CSP 26-006AL (BP030) – ADDENDUM No.01
Willowridge HS Renovations

Fort Bend Independent School District
2023 Bond Program

addendum

PROJECT BP030 Willowridge High School Fine Arts Addition and Renovation, 2023306
PROJECT NO. CSP 26-006AL
ADDENDUM NO. 001
BID PACKAGE ISSUE FOR BID AND PERMIT

1 LEVEL 2 - LIGHTING PLAN - AREA B2
1/8" = 1'-0"

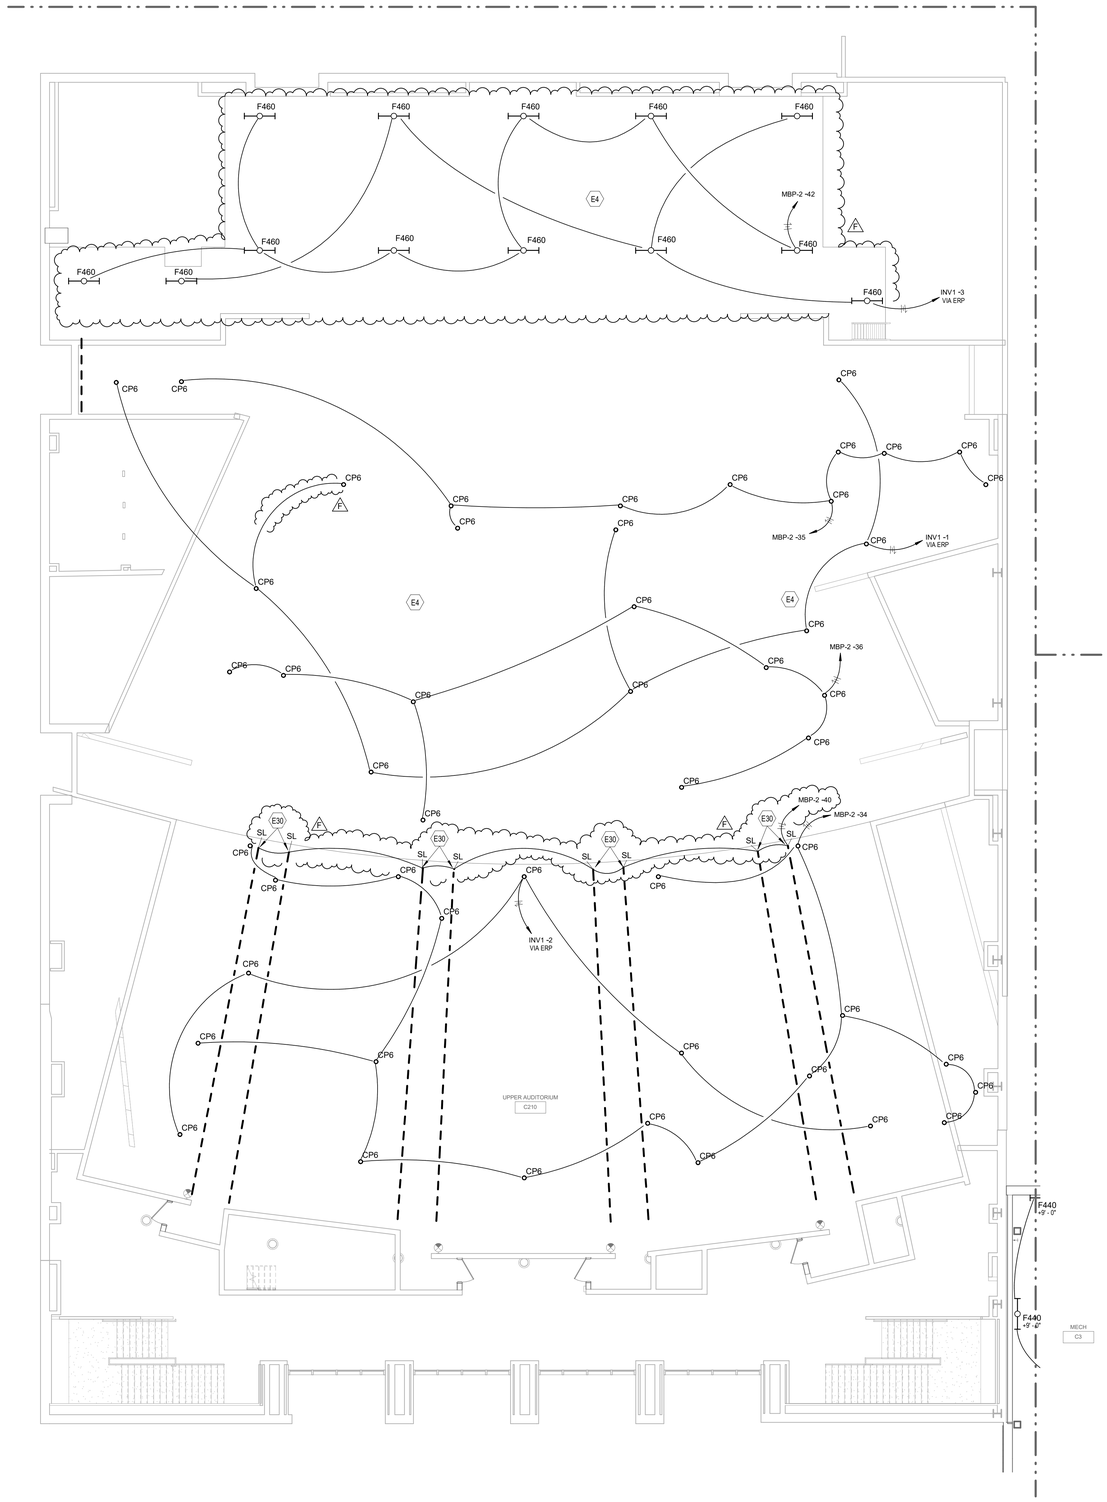
E3.34 LEVEL 2 LIGHTING FLOOR PLAN - AREA B2

1. Aisle lights type SL circuited to MBP-2. Tagged note E30 added to sheet.
2. One cylinder pendant moved to be connected to inverter.
3. Two (2) additional F460 strip fixtures added around stage. All locations are shown for reference to be replaced one-for-one.

1 LEVEL 2 - LIGHTING PLAN - AREA B2 - ALTERNATE
1/8" = 1'-0"

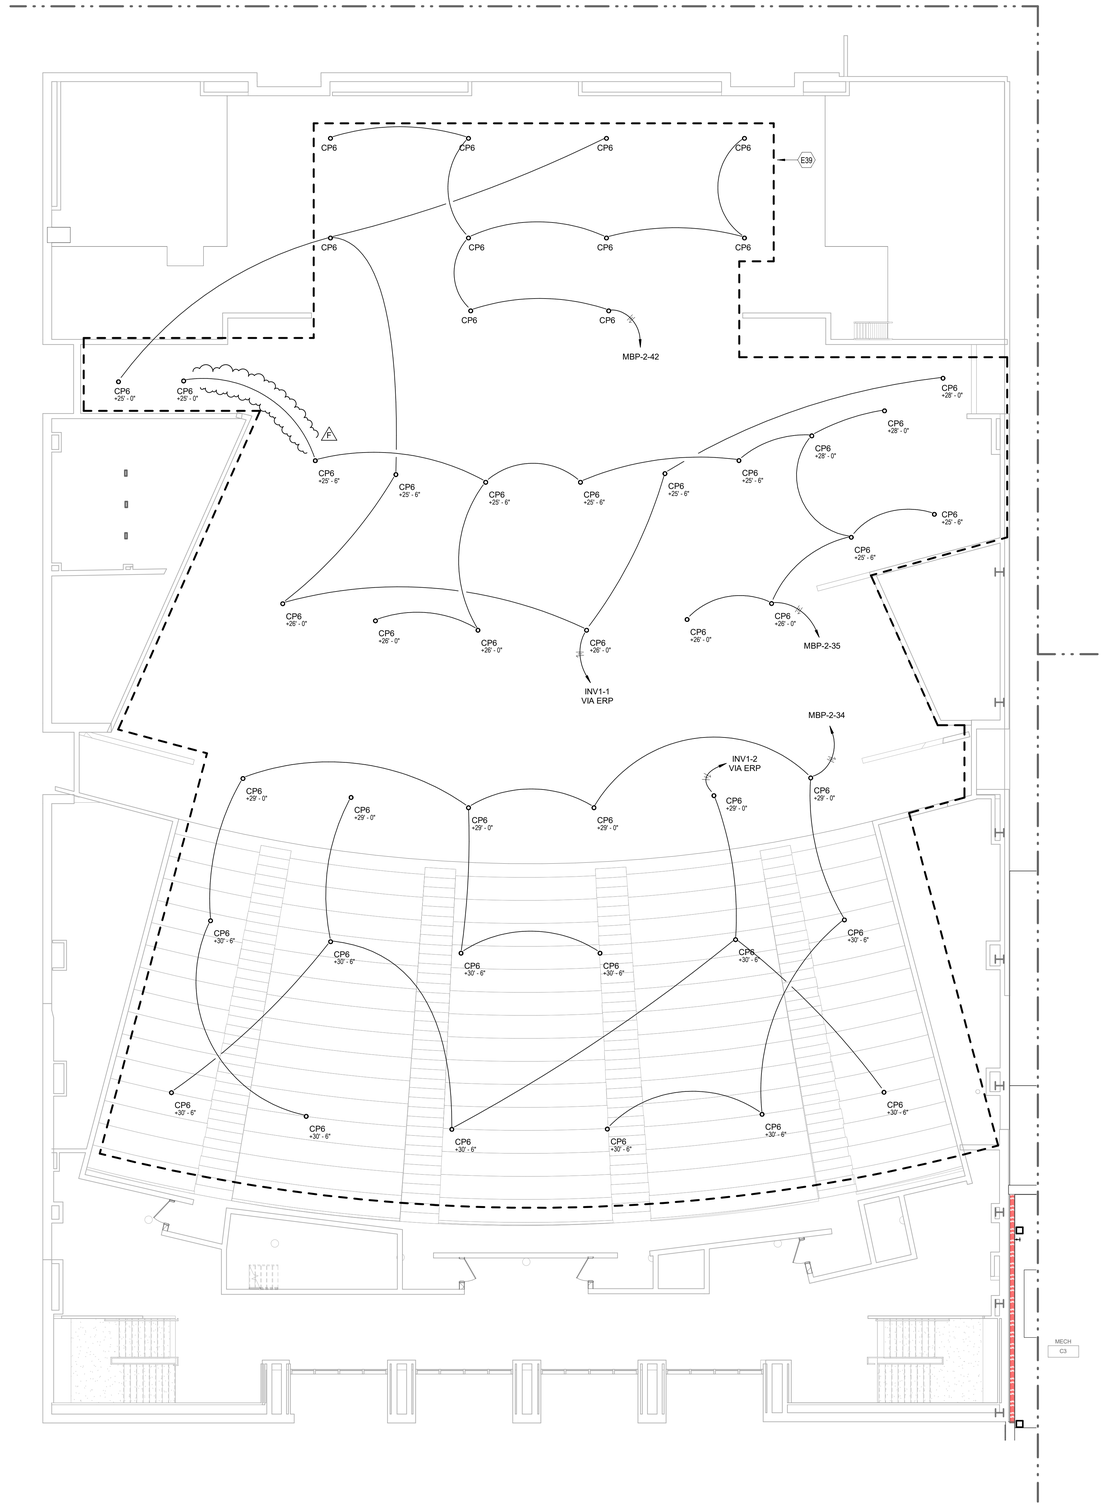
E3.34.A LEVEL 2 LIGHTING FLOOR PLAN - AREA B2 - ALTERNATE

1. Alternate scope for upper-level seating removed from project. Tagged note E40 removed from sheet.
2. Tagged note E39 modified to update alternate number.
3. One (1) CP6 added to lighting circuit.

E3.35 LEVEL 2 LIGHTING FLOOR PLAN - ART ROOM

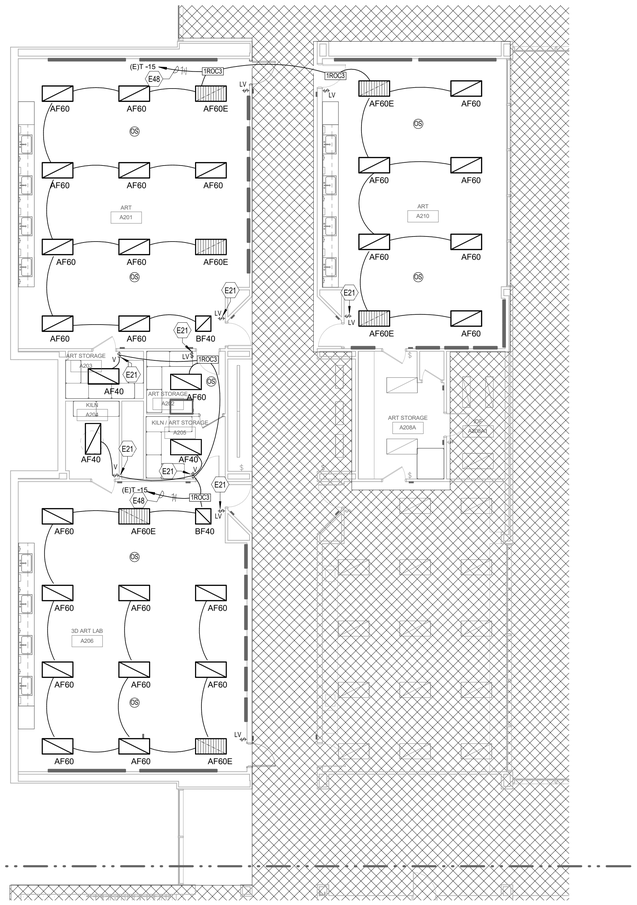
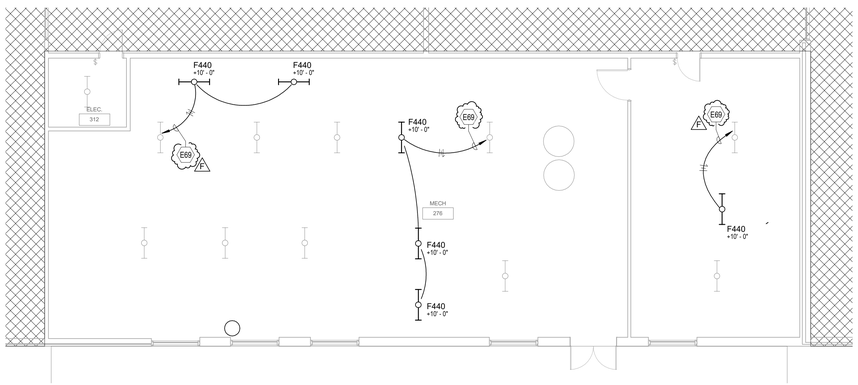
1. Tagged not E69 added to sheet to clarify circuiting for new light fixtures in mechanical rooms.

2 PARTIAL ELECTRICAL ONE-LINE - FIELD HOUSE - NEW
NTS

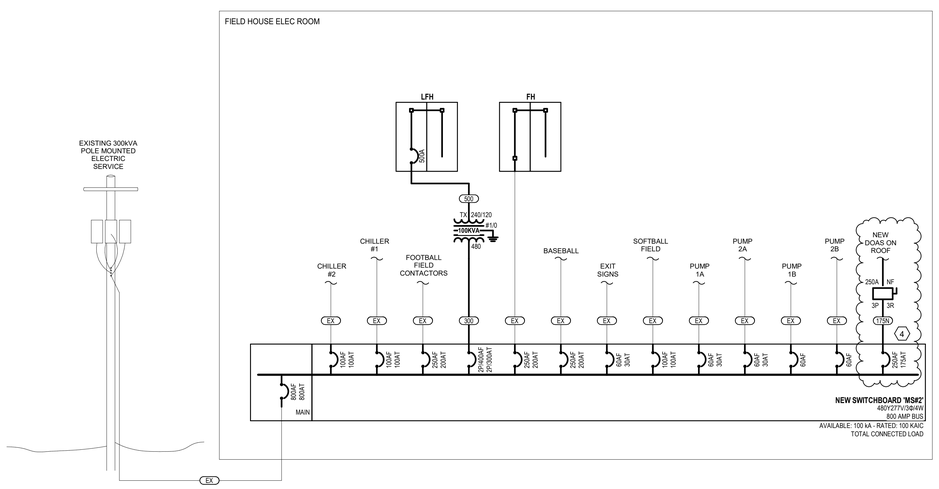
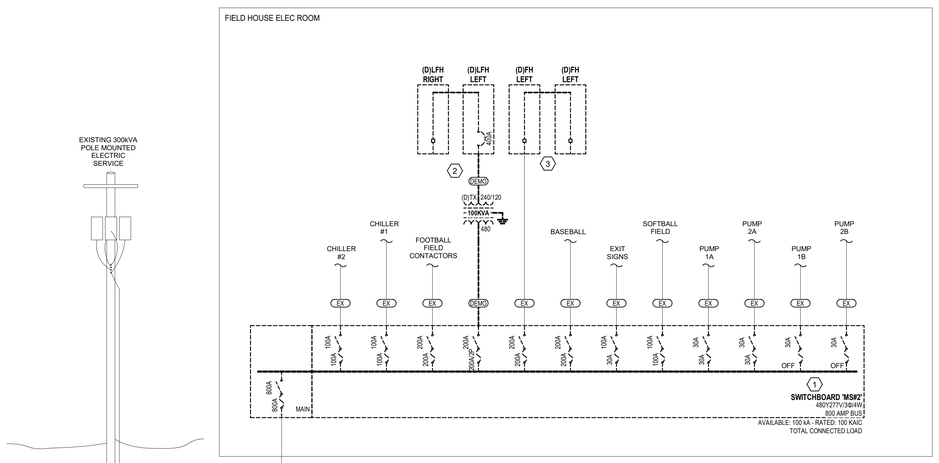
1. Alternate 10 for added DOAS unit added to new one-line diagram.

P1.13 LEVEL 1 & 2 DEMOLITION PLUMBING PLAN - ART ROOMS

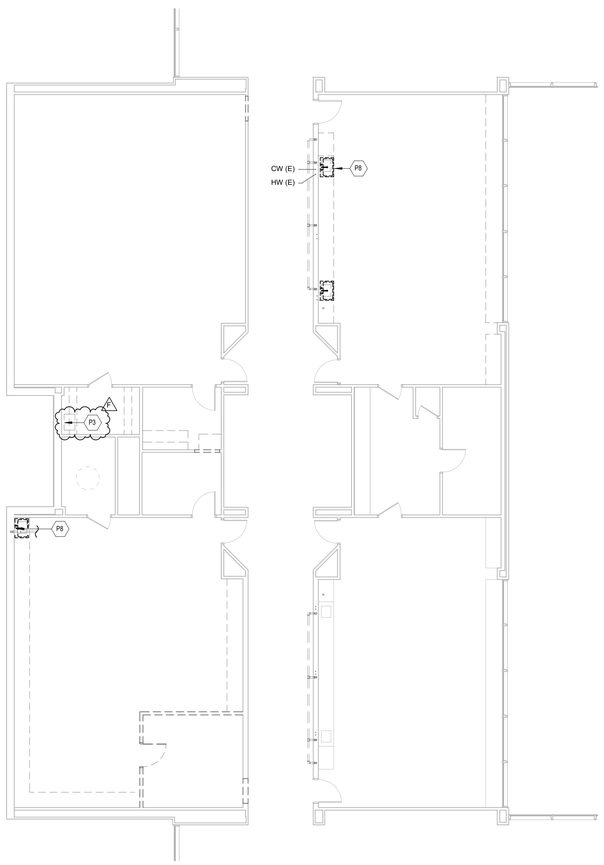
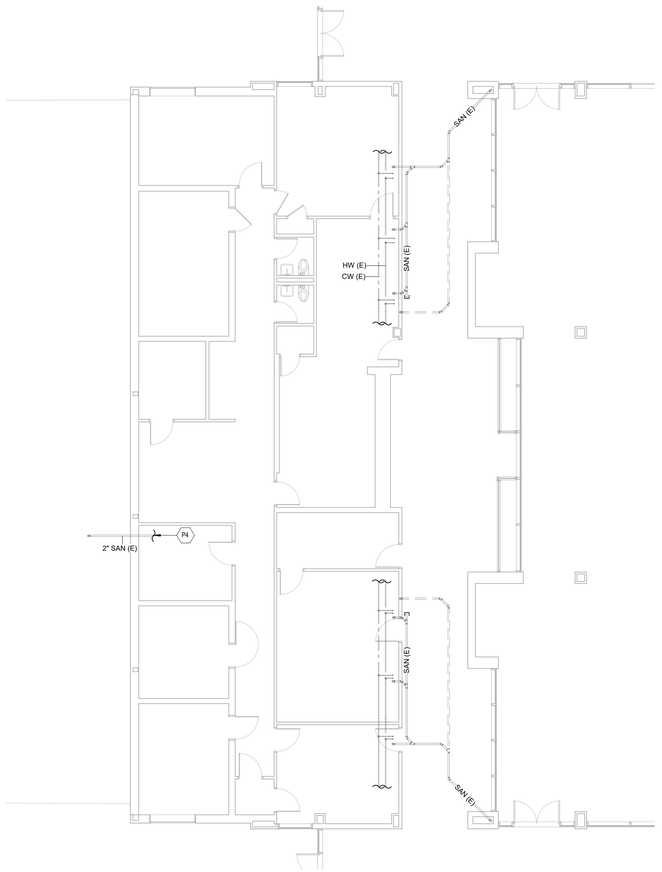
1. Added keynote to demo existing sink.

1 LEVEL 1 BELOW SLAB PLUMBING PLAN - AREA B1
1/8" = 1'-0"

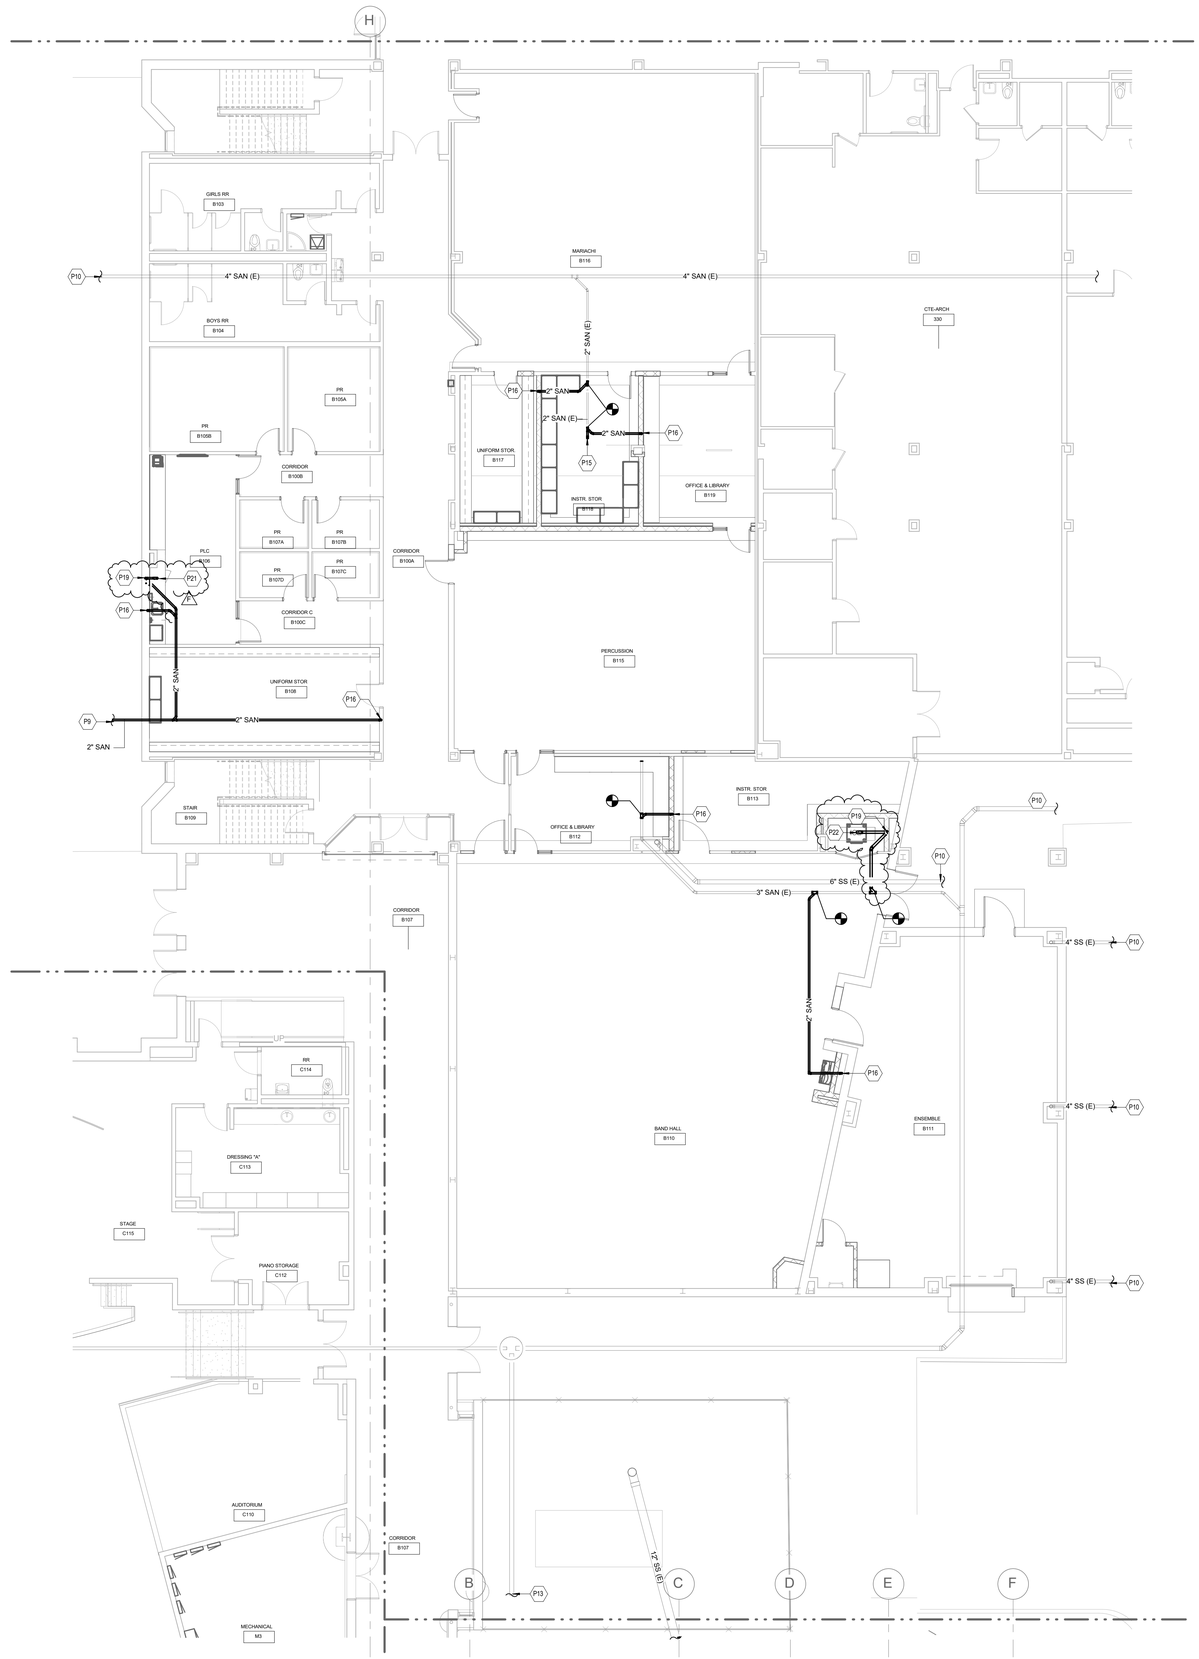
P2.21 LEVEL 1 BELOW SLAB PLUMBING PLAN - AREA B1

1. Added sanitary drain lines to serve FS-1 at ice makers.

1 LEVEL 1 BELOW SLAB PLUMBING PLAN - AREA B2
1/8" = 1'-0"

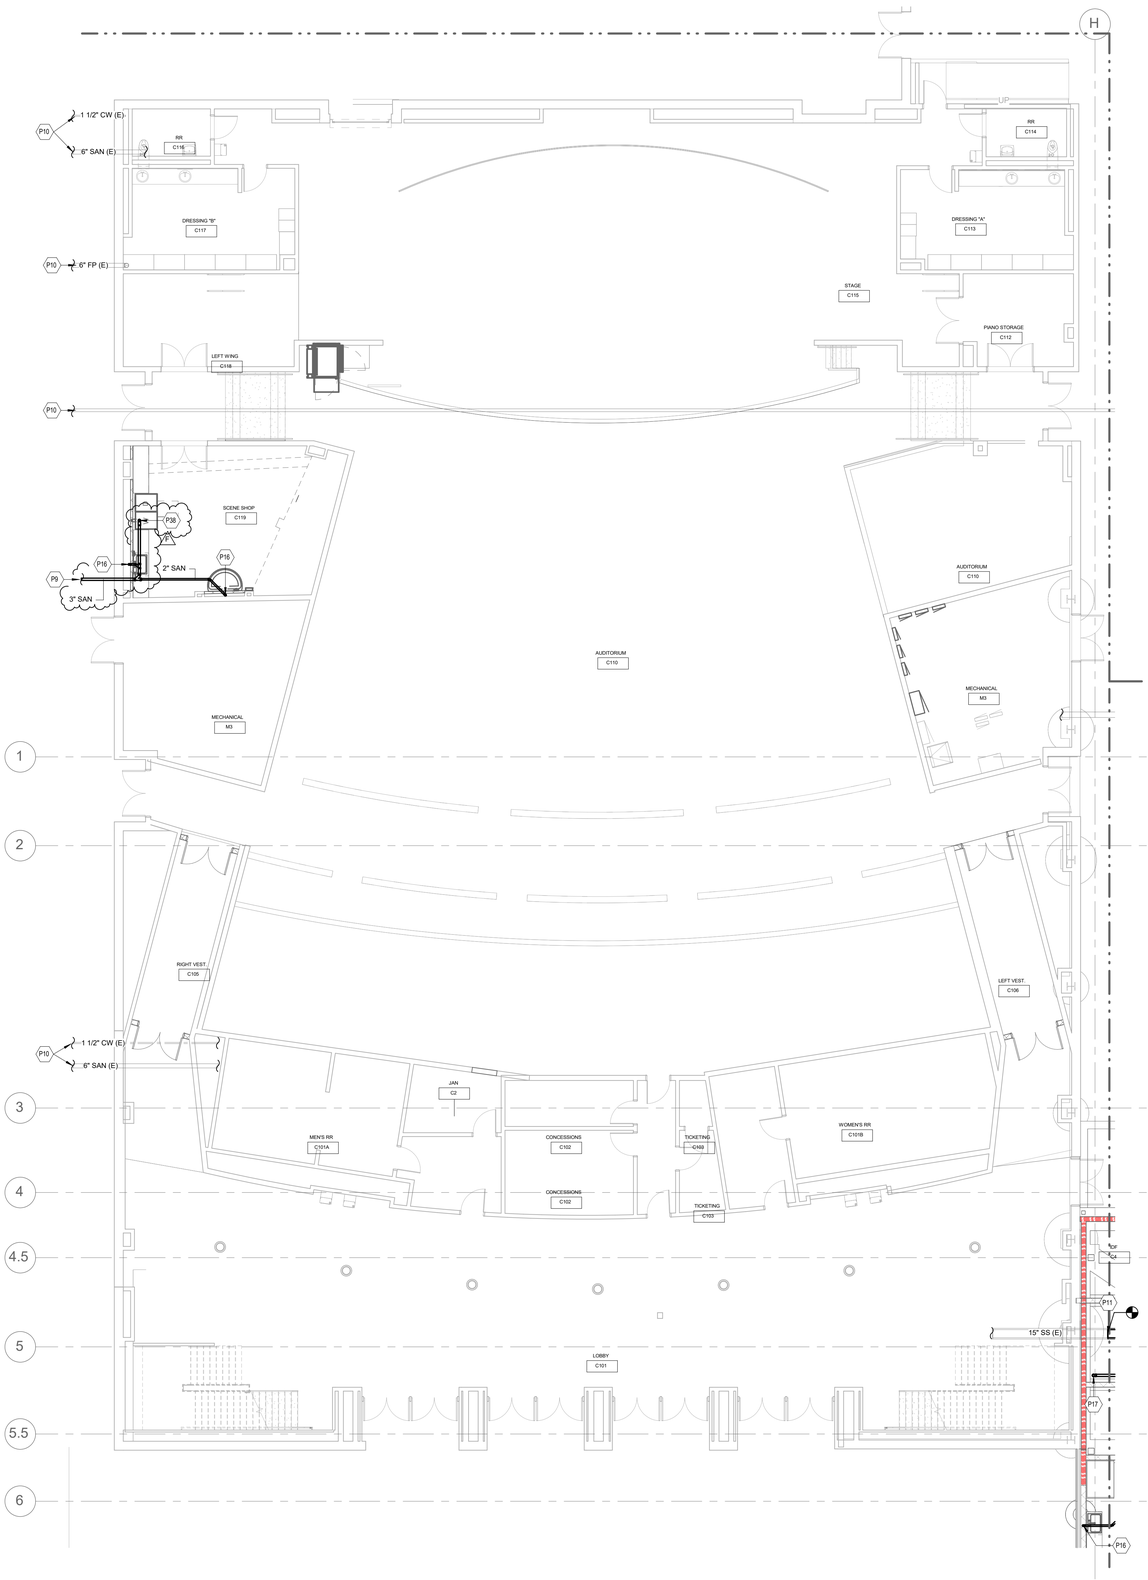
P2.22 LEVEL 1 BELOW SLAB PLUMBING PLAN - AREA B2

1. Increased sanitary line size to accommodate commercial washing machine drain.
2. Added 3” drain line down from trench behind washing machine.
